**RE: U-Haul at West Bluff
Atrisco Drive NW
Grading Plan and Drainage Report
Engineer's Stamp Date 12-5-2016 (File: H11D059)**

Based upon the information provided in your submittal received 12-9-2016, the Grading Plan and Drainage Report are not approved for Building Permit. The following comments need to be addressed for approval of the referenced project:

DRAINAGE MANAGEMENT PLAN

ENGINEER'S SEAL	WEST BLUFF BUSINESS CENTER	DRAWN BY DY
		DATE 11/28/16
		2016061-GRB
RONALD R. BOHANNAN P.E. #7866	 TIERRA WEST, LLC 5571 MIDWAY PARK PLACE NE ALBUQUERQUE, NM 87109 (505) 858-3100 www.tierrawestllc.com	SHEET # GR-1
		JOB # 2016061

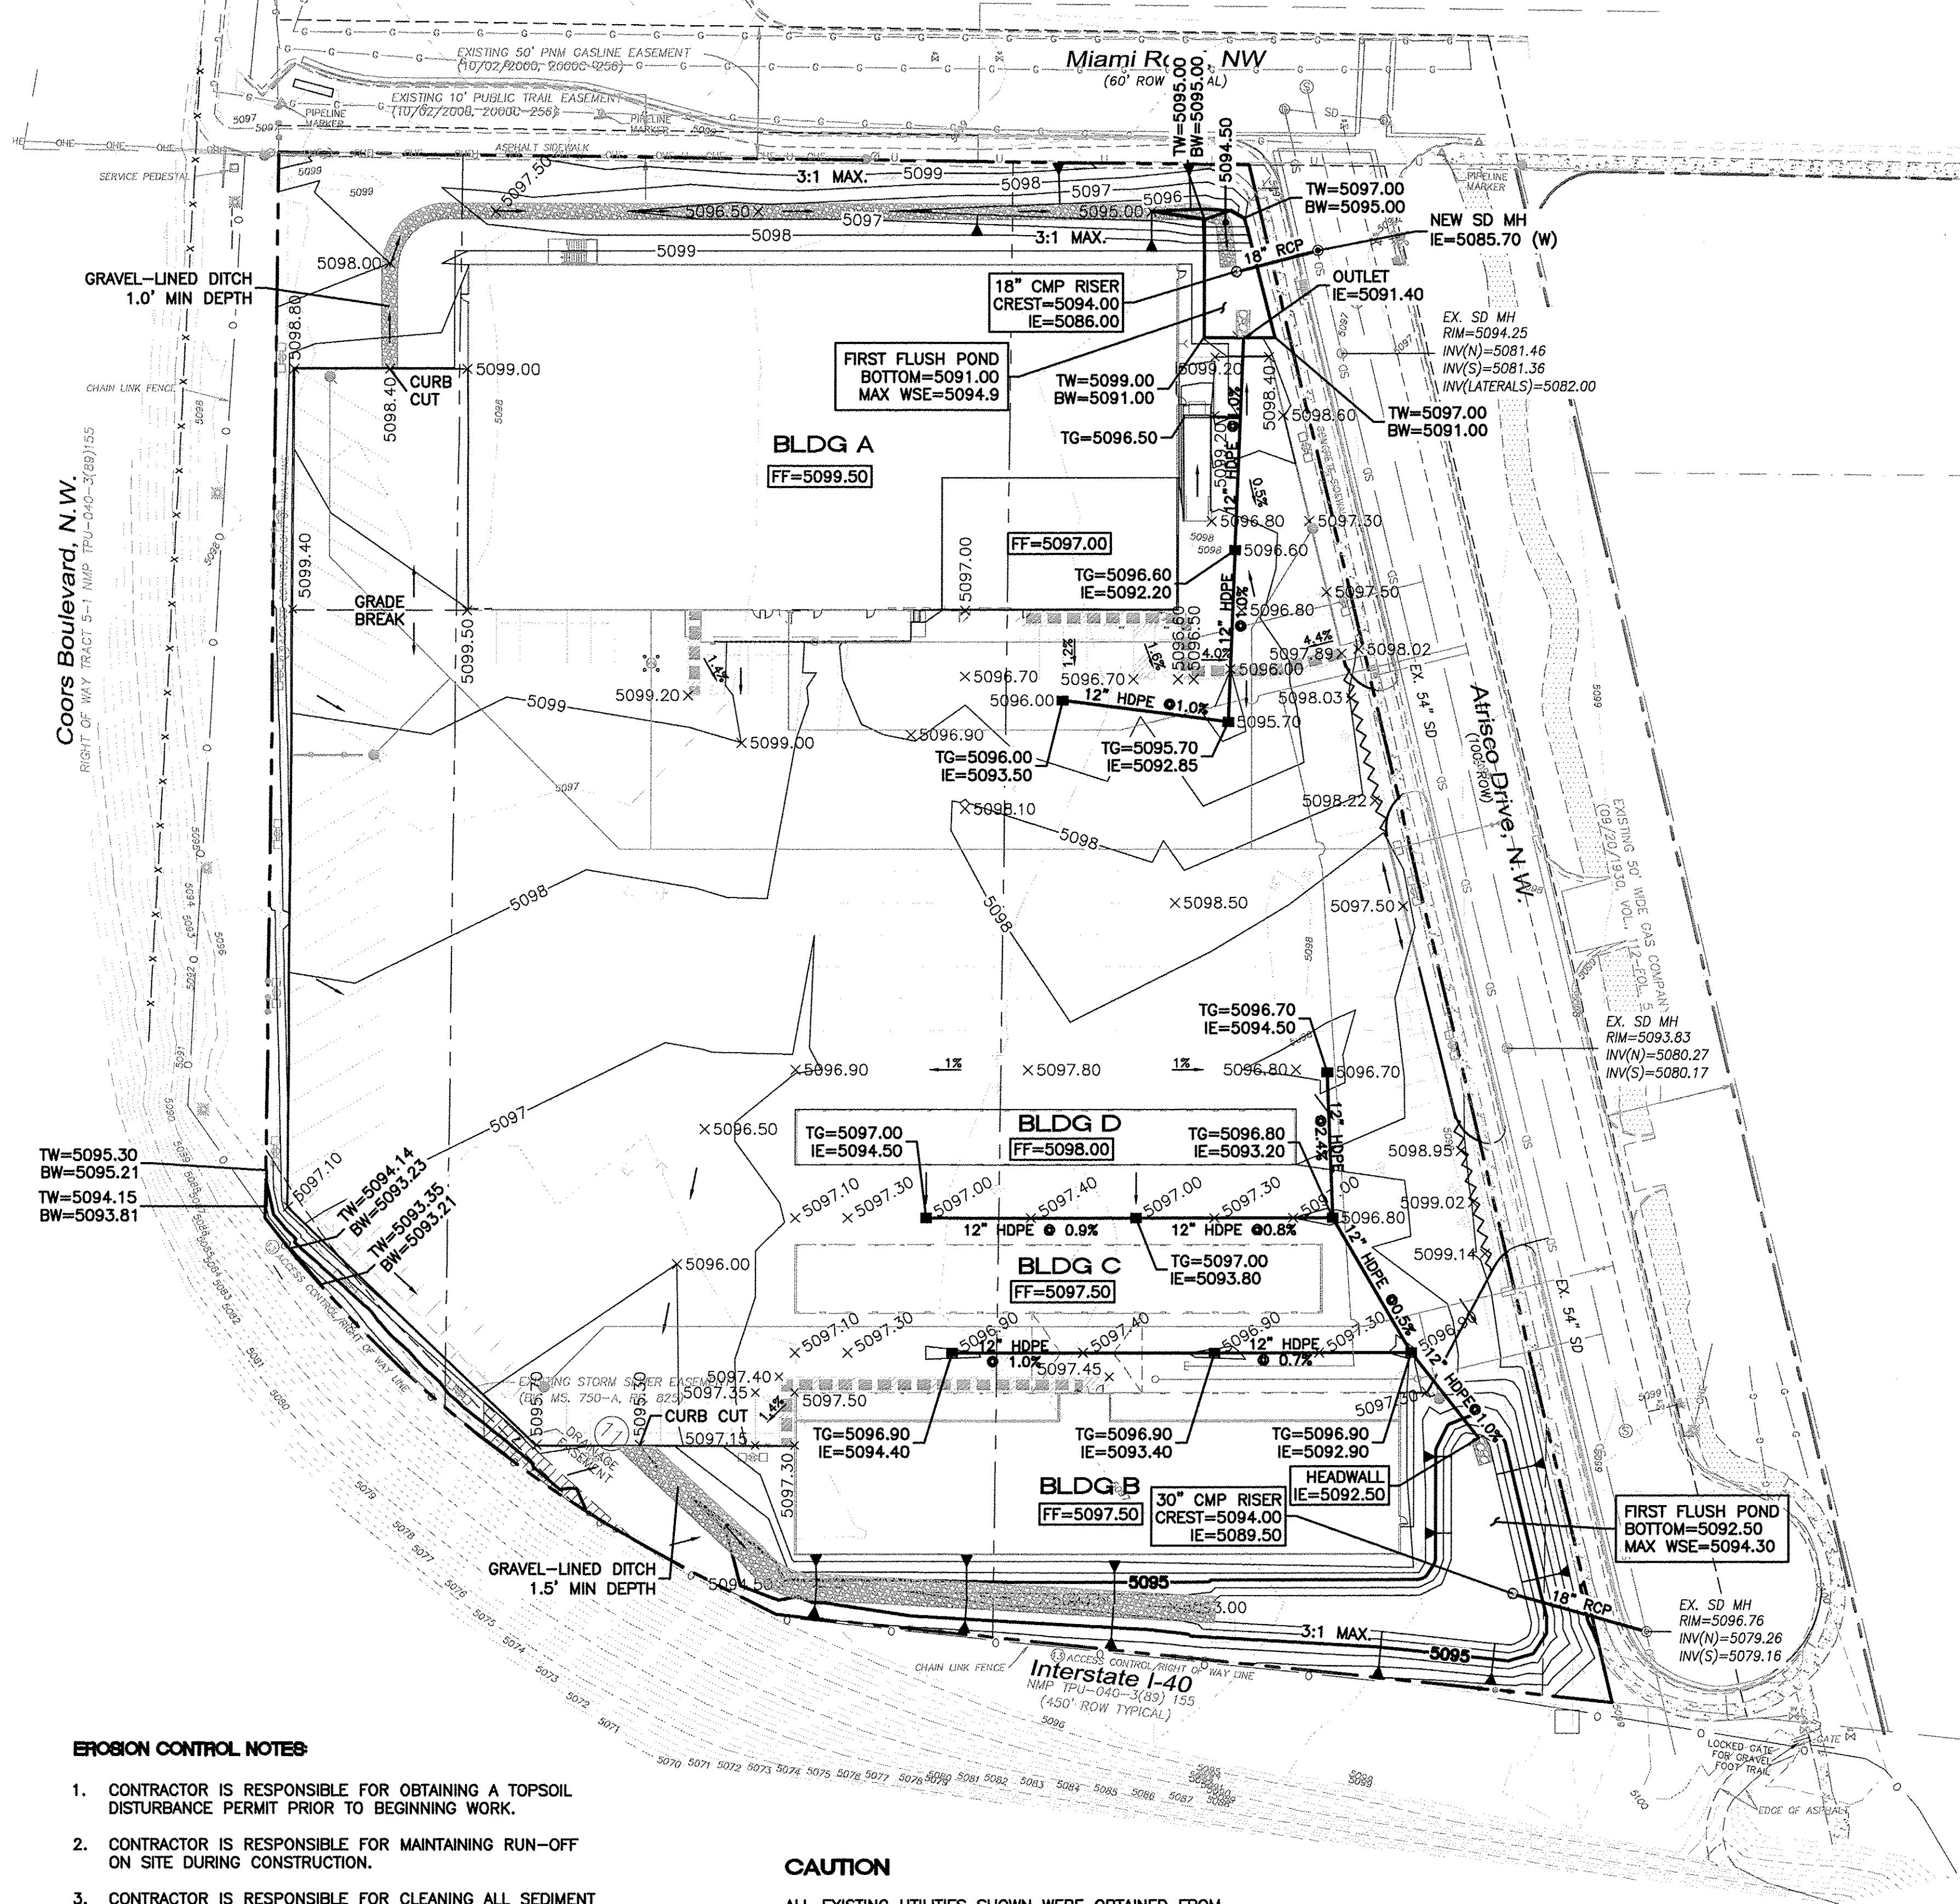
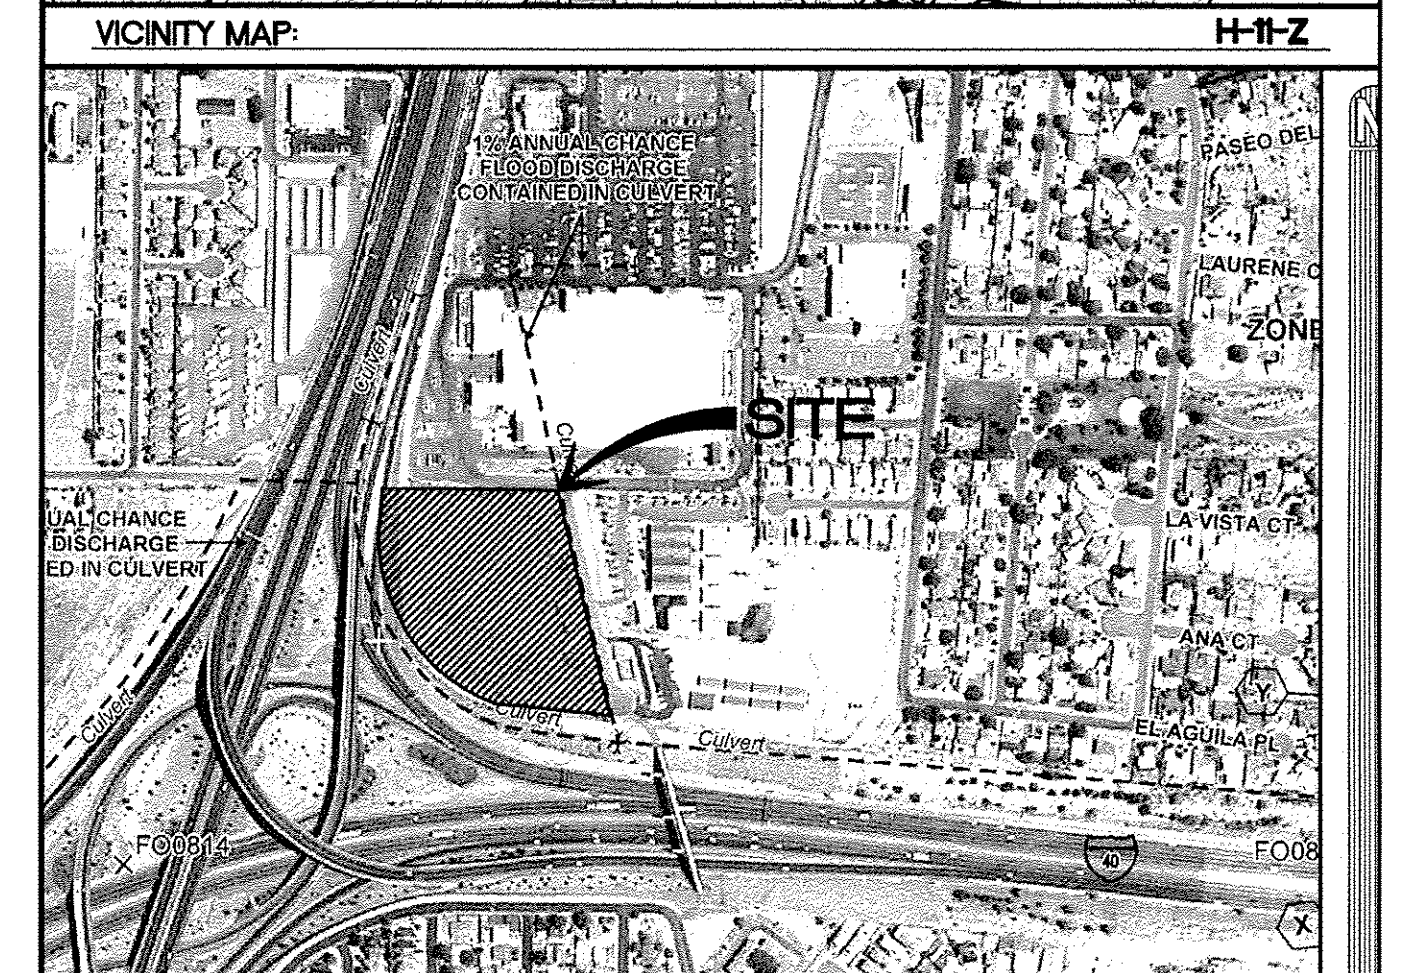
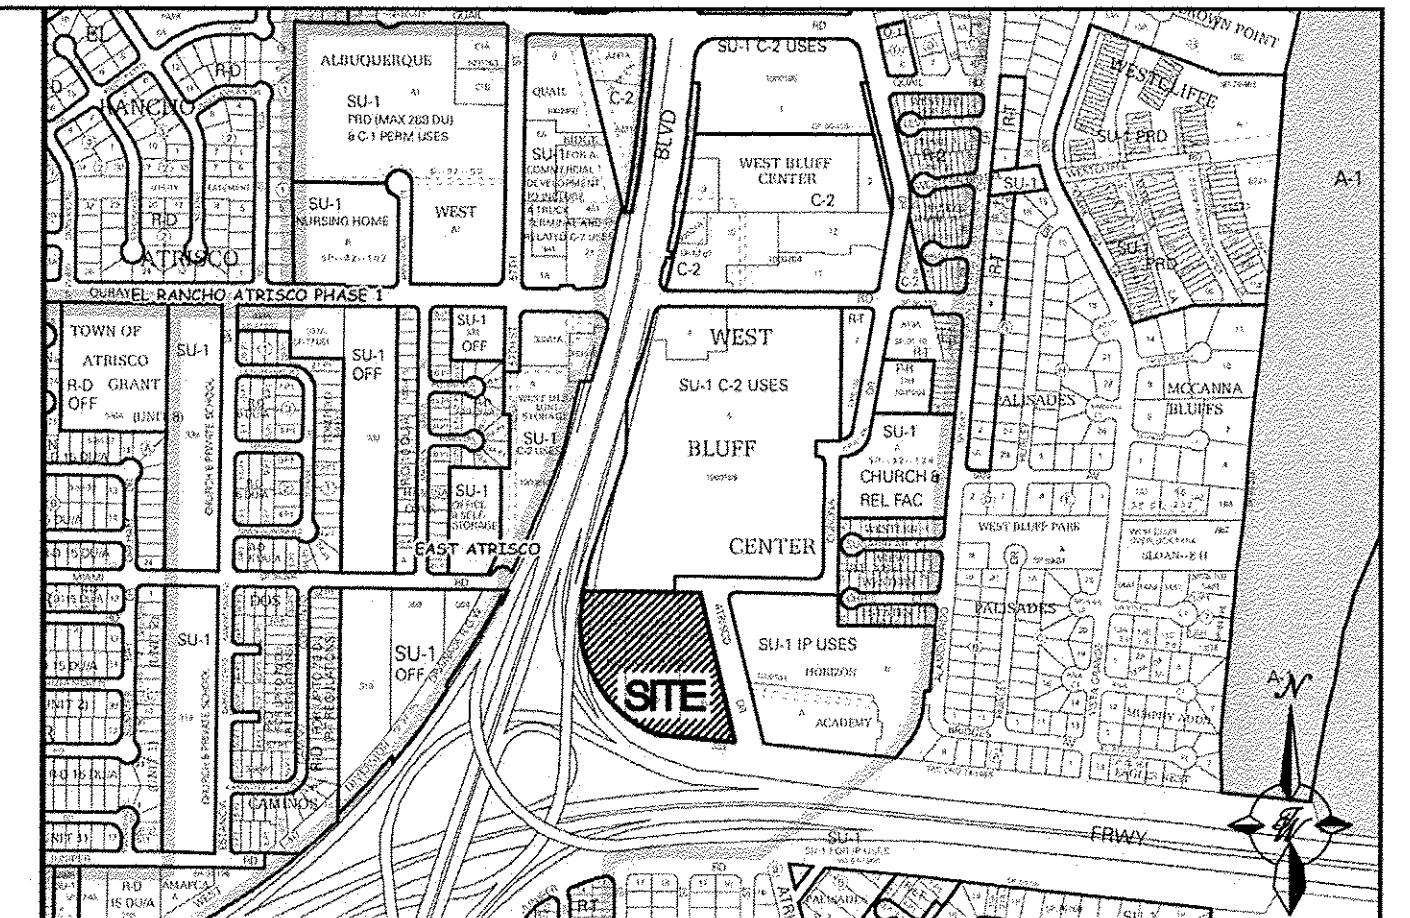
1. The North detention pond appears to be bounded by a CMU retaining wall as high as 8 feet in some places. This will need to be enclosed with a fence at least 42 inches high.

2. Call out Class IV RCP for the north detention pond outfall pipe under the retaining wall.
3. Additional detail is required for the two curb cuts and their associated water blocks to ensure ADA compliance for pedestrian traffic along Atrisco. Provide section views at these locations, including flow line elevation, slope, and waterblock elevations.

4. Project Benchmark and Vertical Datum is missing from the sheets. The Drainage Management Plan addresses the NGVD29 to NAVD88 shift, but sheets need this information as well.

5. A portion of the sidewalk is within the parcel property, if there is no existing sidewalk easement, one will need to be provided.
6. Verify that the two drop inlets are capable of handling twice the 100-yr flow at the sump on Atrisco. It appears this location has a single-C and double-C on each side of the road. If these inlets are insufficient, additional inlets will be needed on the new lateral from the north pond to prevent flows from spilling over into the north pond.
